UNITED STATES PATENT AND TRADEMARK OFFICE

| APPLICATION NO. | FILING DATE | FIRST NAMED INVENTOR | ATTORNEY DOCKET NO. | CONFIRMATION NO. |
|--|-------------|----------------------|----------------------------|------------------------|
| 10/567,975 | 02/10/2006 | Chojiro Kuriyama | 10921.381USWO | 5511 |

Office Action Summary

DETAILED ACTION

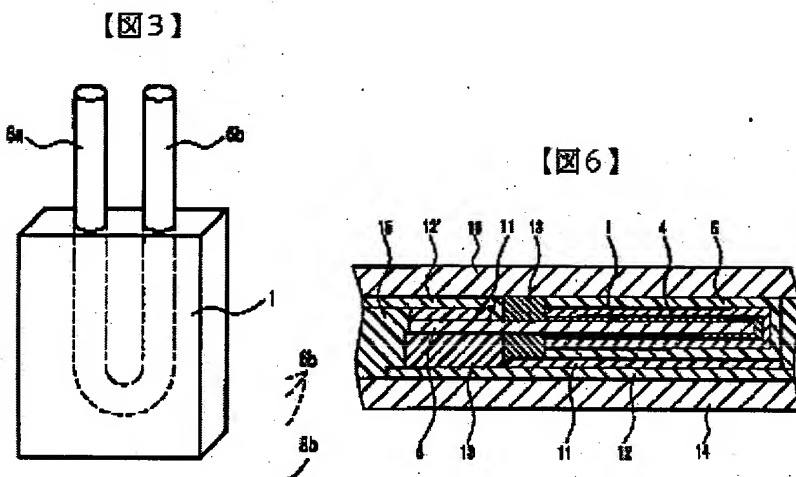
4. Claims 1, 3, and 10 are rejected under 35 U.S.C. 102(a) as being anticipated by Masanori et al. (JP 2003332173).

Masanori et al. disclose in fig. 3, a solid electrolytic capacitor comprising: a porous sintered body of metal particles ceramic particles; an anode partially inserted in the porous sintered body or conductive sintered body; second anode terminals provided by portions project from the porous sintered body; and a cathode formed on an obverse surface of the porous sintered toward the body, wherein circuit current flows from the first anode terminal toward the second anode terminal through the porous sintered body.

Regarding claim 3, Masanori et al. disclose the anode comprises an anode wire having opposite ends projecting from the porous sintered body; and wherein the first and the second anode terminals are provided by the opposite ends.

Regarding claim 10, Masanori et al. disclose the first anode terminal is higher in equivalent series inductance than the second anode terminal.

FIG. 3

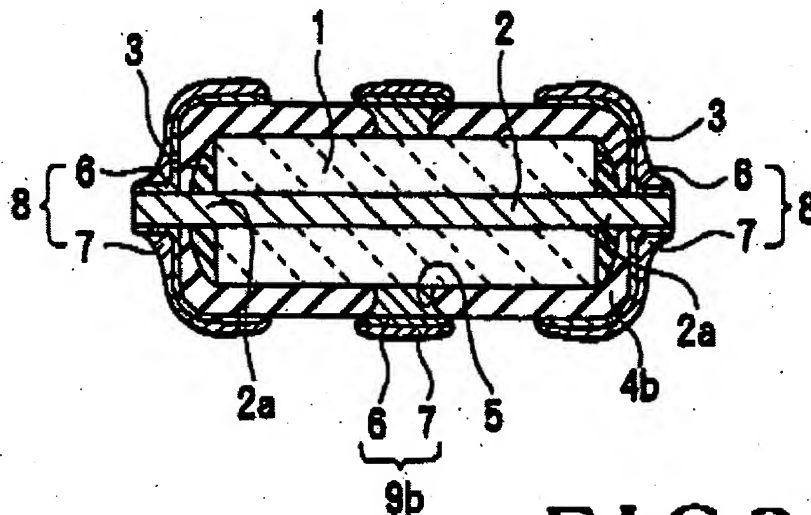
5. Claims 1, 3, 5-6, 7-8 are rejected under 35 U.S.C. 102(b) as being anticipated by Taniguchi (US 5,184,287).

Taniguchi discloses a solid electrolytic capacitor comprising a porous sintered body of metal particles or conductive ceramic particles; an anode partially inserted in the porous sintered body; a first and a second anode terminals provided by portions of the anode which project from the porous sintered body; and a cathode formed on an obverse surface of the porous sintered body; wherein circuit current flows from the first anode terminal toward the second anode terminal through the porous sintered body (inherent feature). When the structure recited in the references is substantially identical to that of the claims, claimed properties or functions are presumed to be inherent.

Regarding claim 3, Taniguchi discloses the anode comprises an anode wire having opposite ends projecting from the porous sintered body; and wherein the first and second anode terminals are provided by the opposite ends.

Regarding claim 5, Taniguchi discloses the porous body is in a form of a flat plate.

Regarding claim 7, Taniguchi discloses the porous sintered body includes at least two side surfaces standing in a thickness direction; and wherein the first and the second anode terminals projected from two different side surfaces.

Regarding claim 8, Taniguchi discloses the porous sintered body is flat in section.

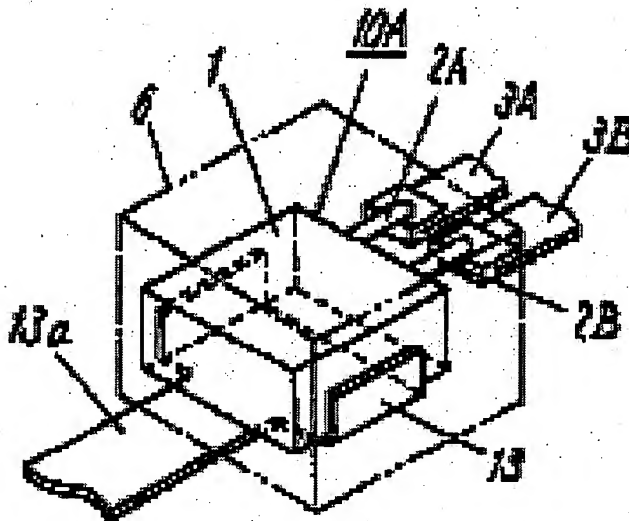
8. Claims 1-2, 5-6, 9, 11, 13, 15-17 are rejected under 35 U.S.C. 103(a) as being unpatentable over JP 2000-306774 ('774) in view of Edson et al. (US 2004/0066607).

'774 discloses in fig. 6, a solid electrolytic capacitor comprising: a porous sintered body of metal particles or conductive ceramic particles (1); an anode (2) welded to the porous sintered body; a first and a second anode terminals provided by portions of the anode which project from the porous sintered body; and cathode formed on an obverse surface of the porous sintered body; wherein circuit current flows from the first anode terminal toward the second anode terminal through the porous sintered body.

'774 discloses the claimed invention except for the anode being partially inserted in the porous sintered body.

Edson et al. teach (paragraph 49) that anode wires can be partially inserted into sintered anode bodies of solid electrolytic capacitors.

It would have been obvious to a person of ordinary skill in the art at the time the invention was made to form the capacitor of '774 with embedded anode wires, since such a modification would eliminate the need to weld the anode wire to the compact.

Regarding claim 2, '774 discloses the anode comprises a plurality of anode wires (2A, 2B).
